**TWENTY WAYLAND, LLC**

Re: Site Plan I  
Phase I Permit Application  
Town Center Project  
400 Boston Post Road  
Wayland, MA

Project Name:  
**WAYLAND TOWN  
 CENTER  
 WAYLAND, MA**

Drawing No.:
<b>FIG.-5</b>
Project No.: 06032

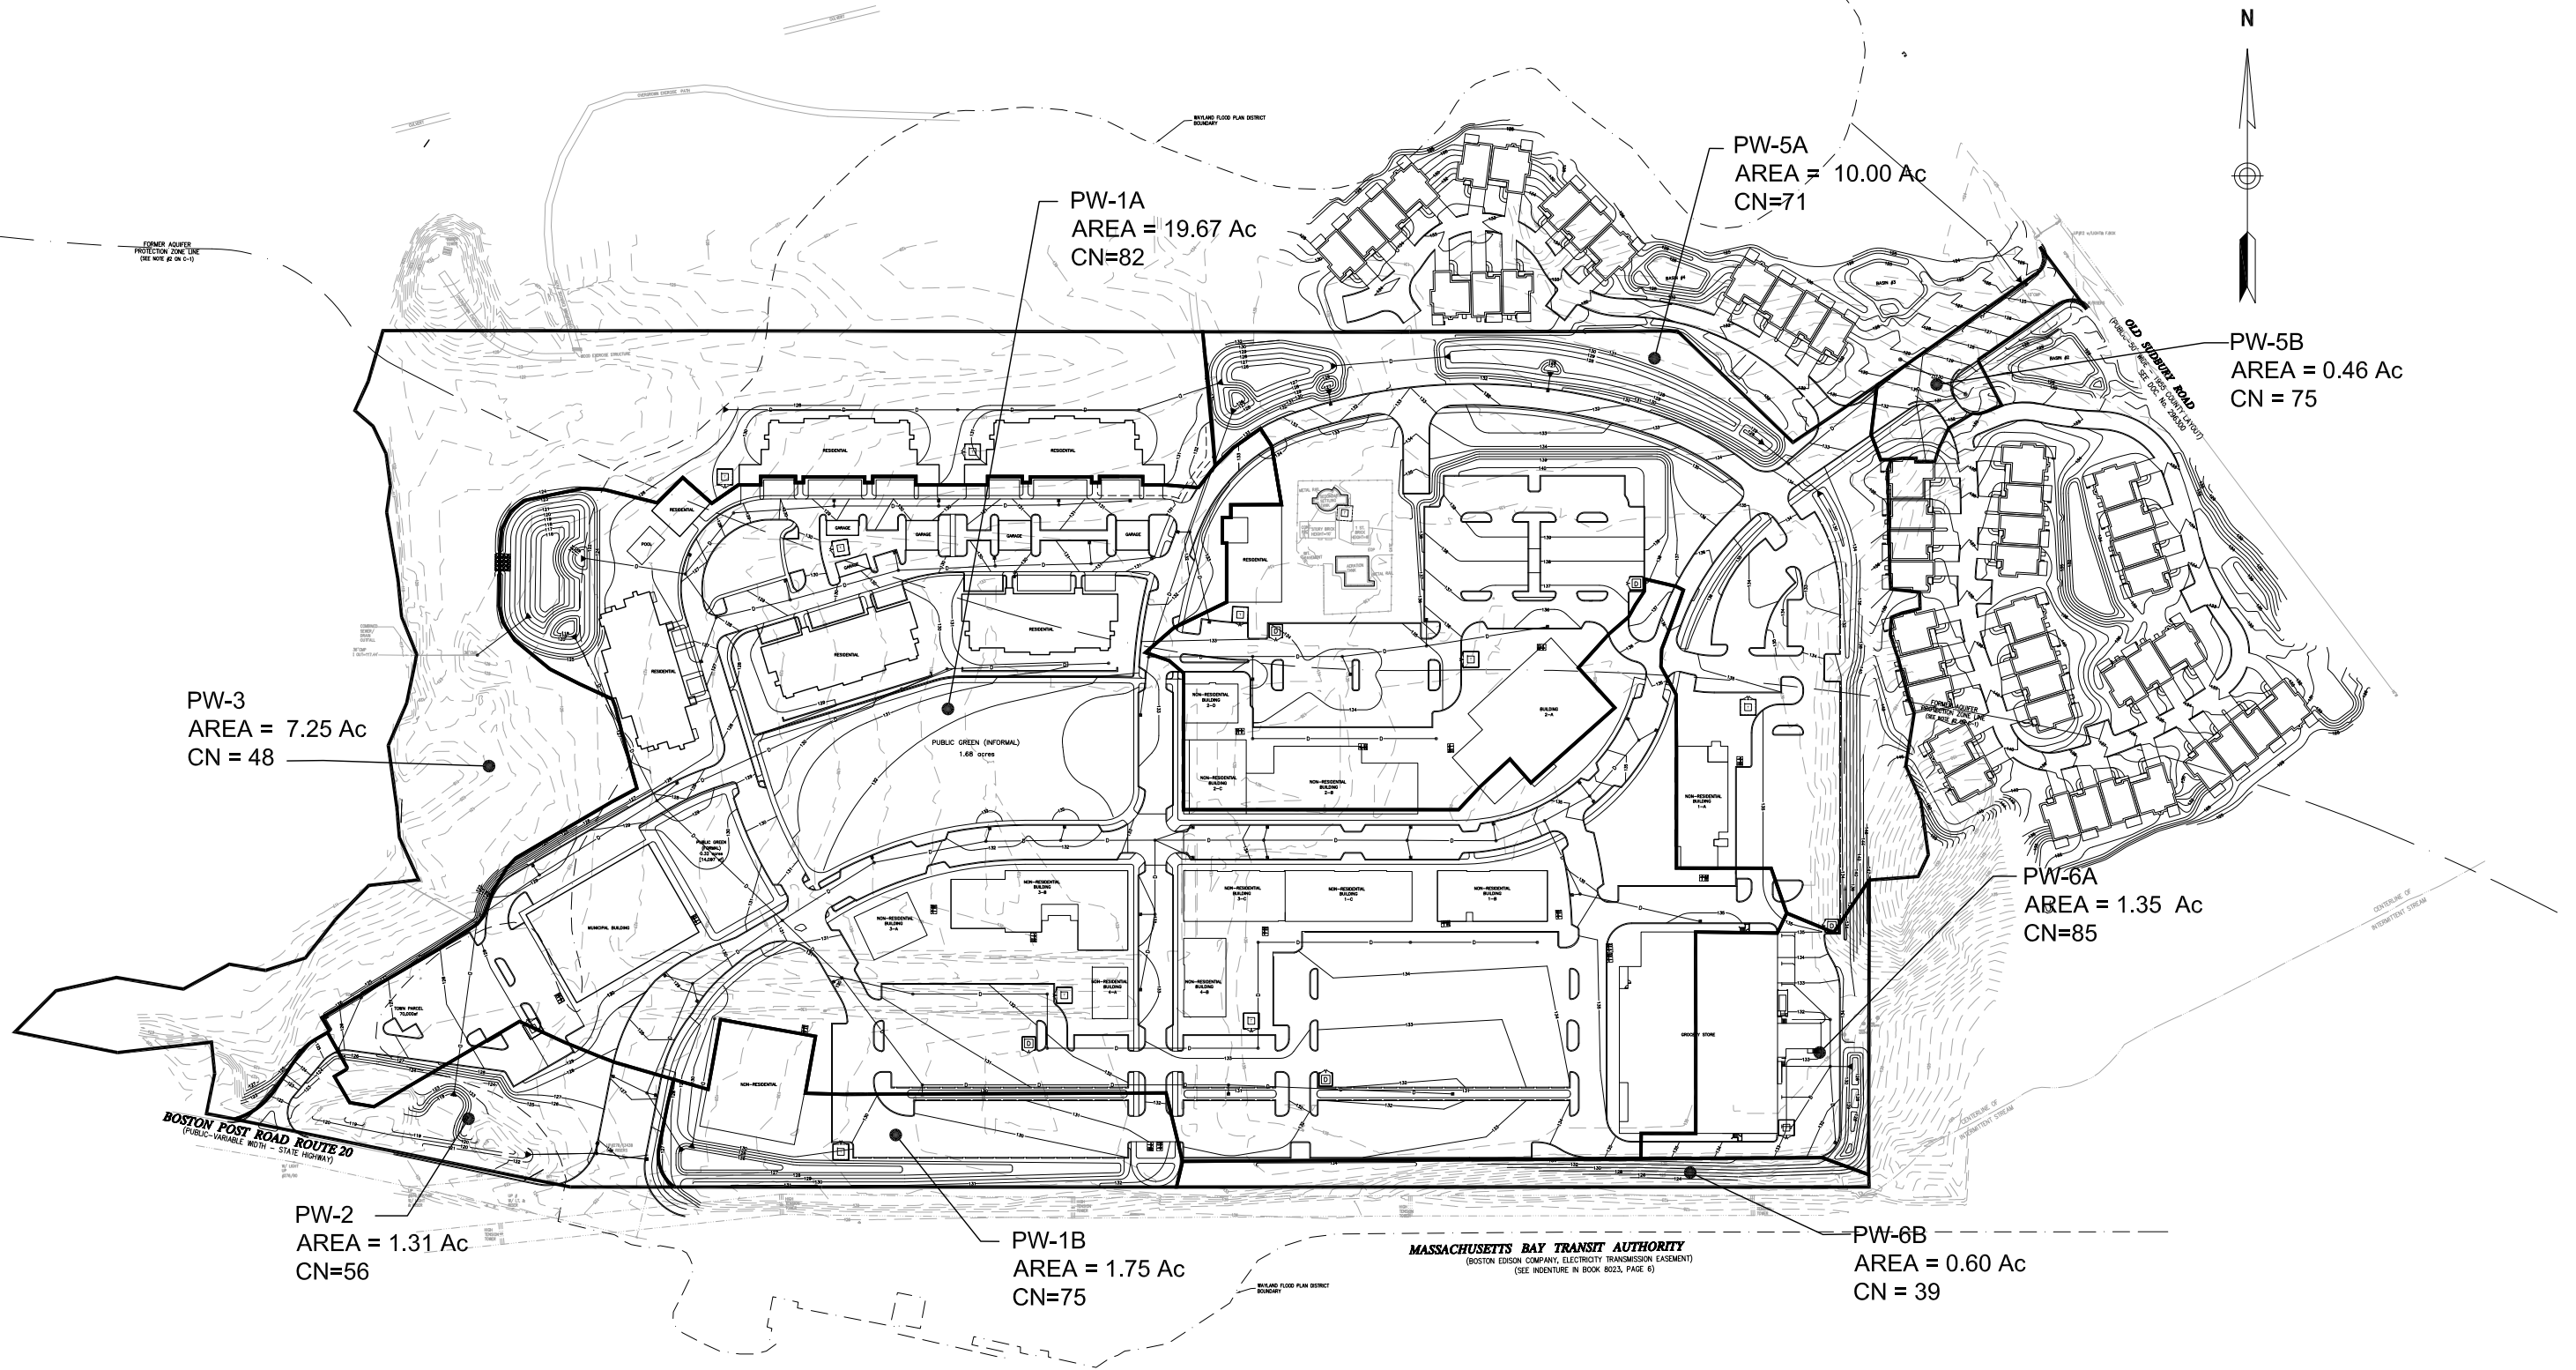
1. *Based on Figure 5 in the stormwater report it appears that the post-development analysis has not been updated to reflect the changes made to the municipal parking area. Drainage improvements to Boston Post Road have not been considered in the drainage calculations.*

**Applicant's Response:** Figure 5 has been updated to reflect the changes made to the municipal parking area. Drainage improvements to Boston Post Road have also been added to the drainage calculations.
